River District Design Commission

SEPTEMBER 10, 2020

AGENDA

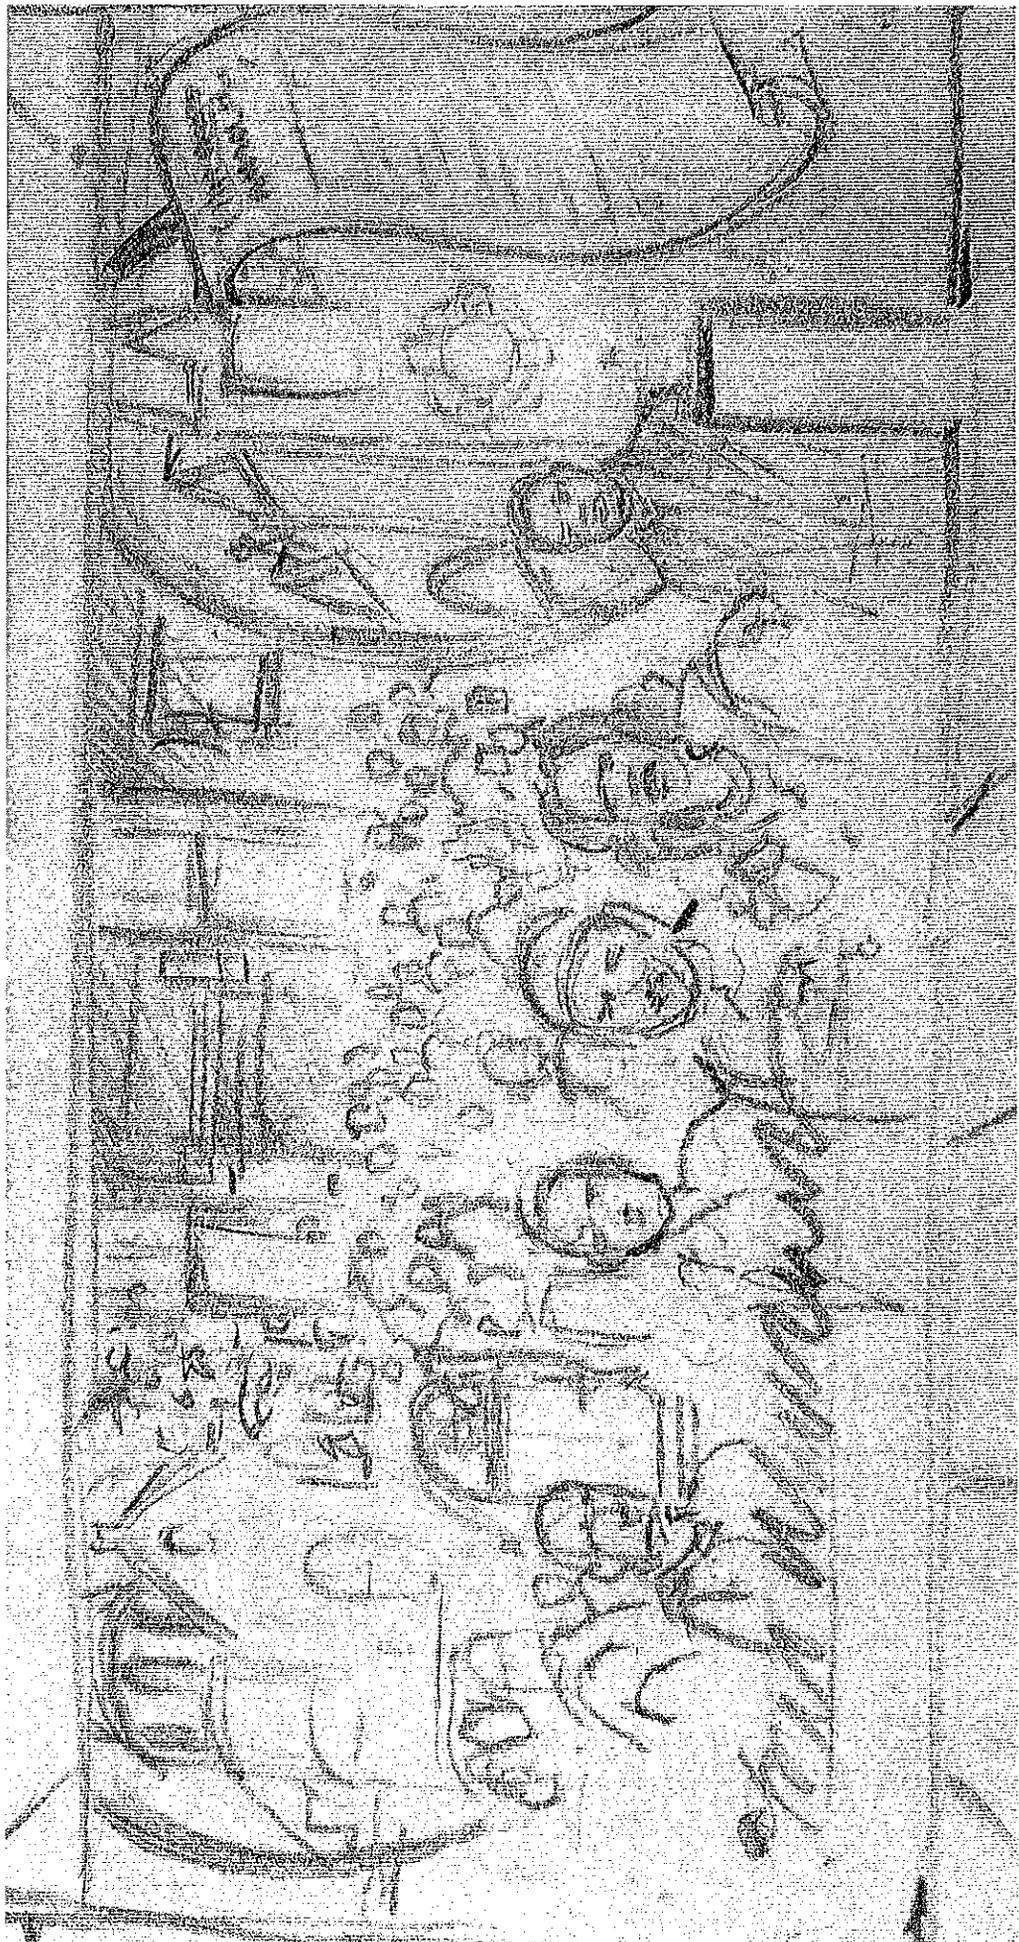
Staff requests that an actual color rendering of the final mural design be provided. The schematic drawings provided at this point do not give sufficient detail for staff to recommend the Issuance of a Certificate of Appropriateness at this time.

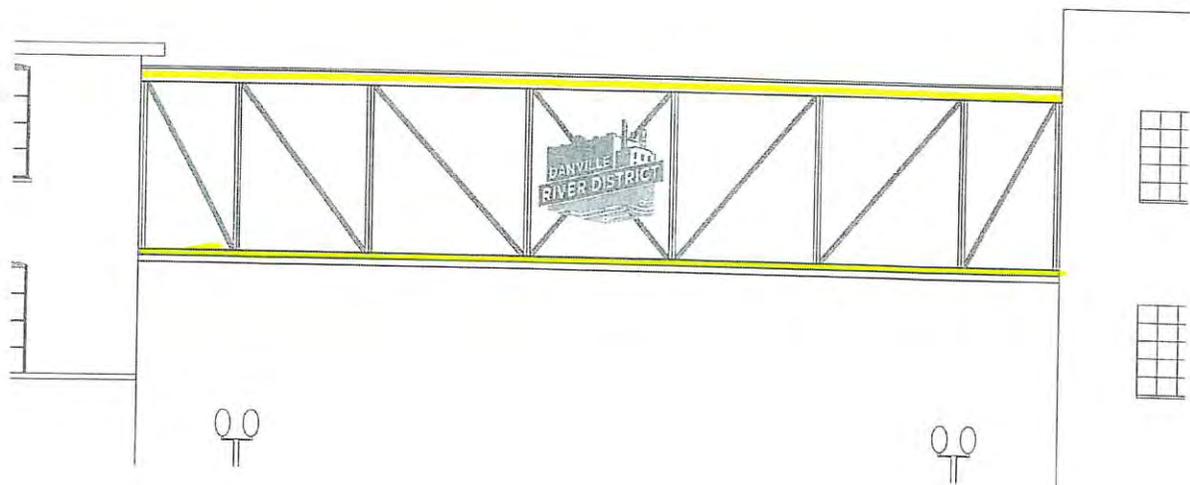
This type of request is not specifically addressed in the guidelines, but there is a reference to lighting the dual bridges to create a dramatic gateway feature and to creating some type of mural on the Craghead Street underpass, therefore the concept of having unique, special features at these entryway locations is supported. Staff recommends the River District Design Commission issue a Certificate of Appropriateness for the Bridge Street bridge over the street to create an art installation that consists of multi-colored LED lights for a beautiful entry/exit to the River District. The multi-colored LED lights in the art installation may not blink, strobe, move, or change in such a manner that creates a safety hazard for passing pedestrian or vehicular traffic.

RIVERSIDE
CROSSFIT

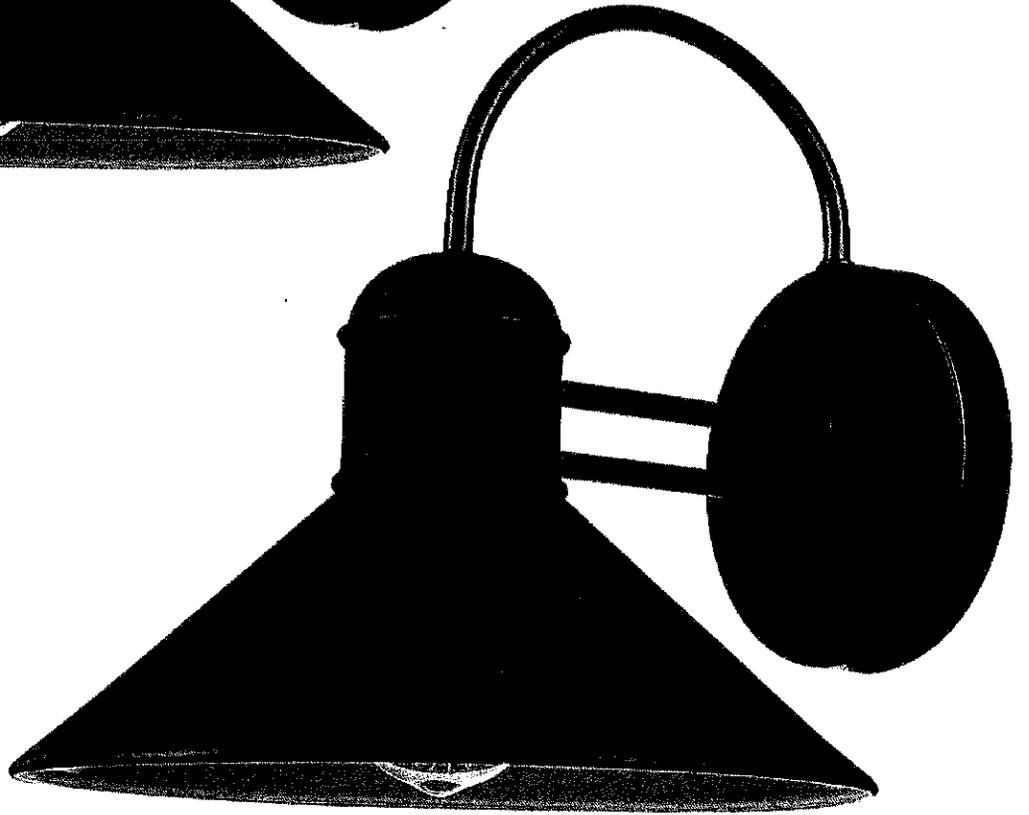
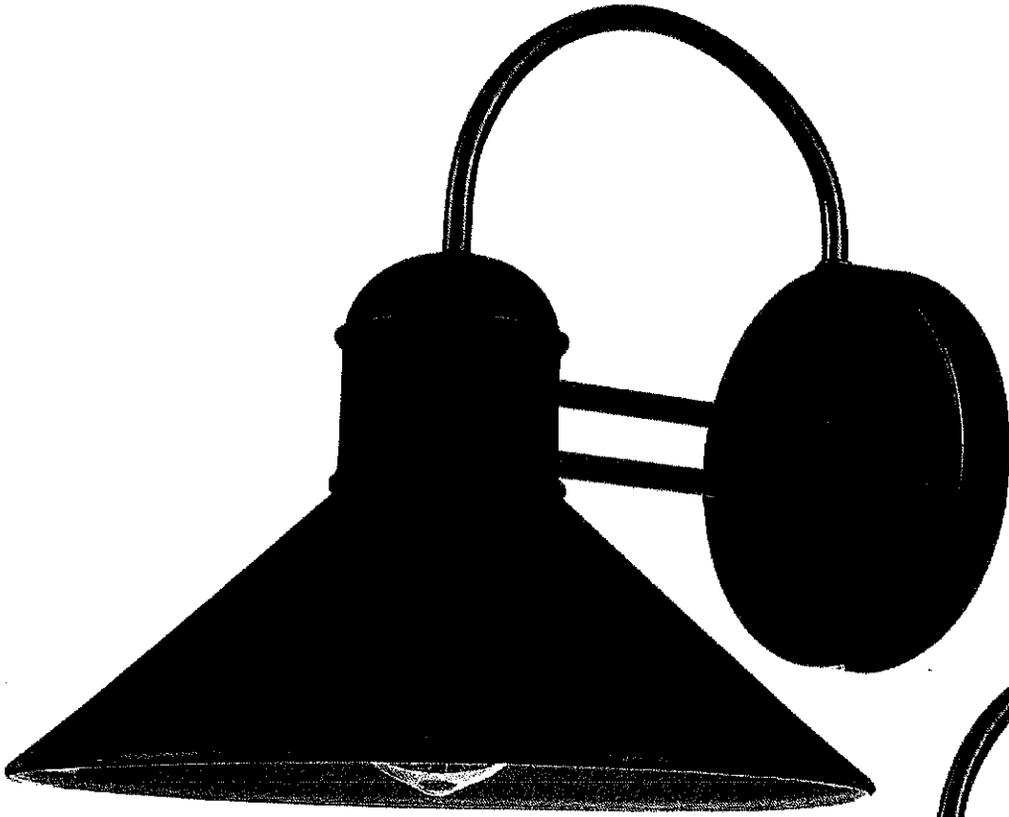
The guidelines permit 20% of door coverage. The door is 11 sq. ft., which allows for 2.2 sq. ft. of coverage (20%). The initial request was for a 2' x 2' sign (2 sq. ft.) which exceeded the maximum. The applicant has agreed to change the size to 18" x 18" which will comply with the guidelines. The wall signage meets size requirements.

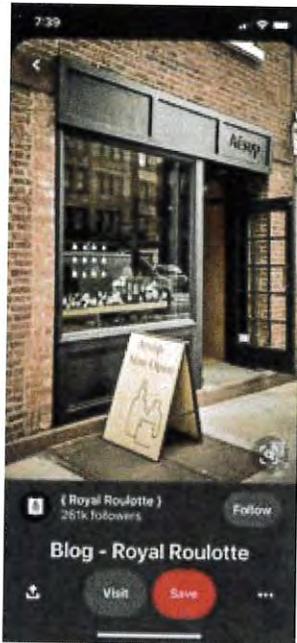
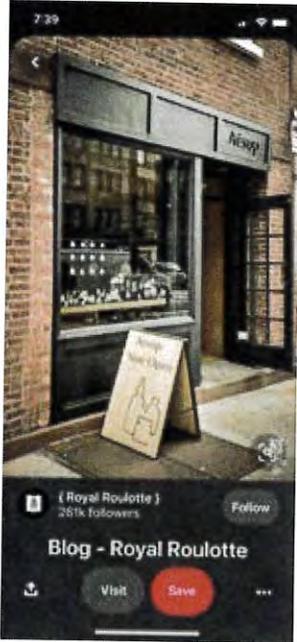
Staff has questions at the time of this report on finalization of the façade (paint, sealer,???), what type of window will be installed, will the existing small front windows be replaced as it appears that the concrete below them is not original and was just a filler material, as well as other questions.
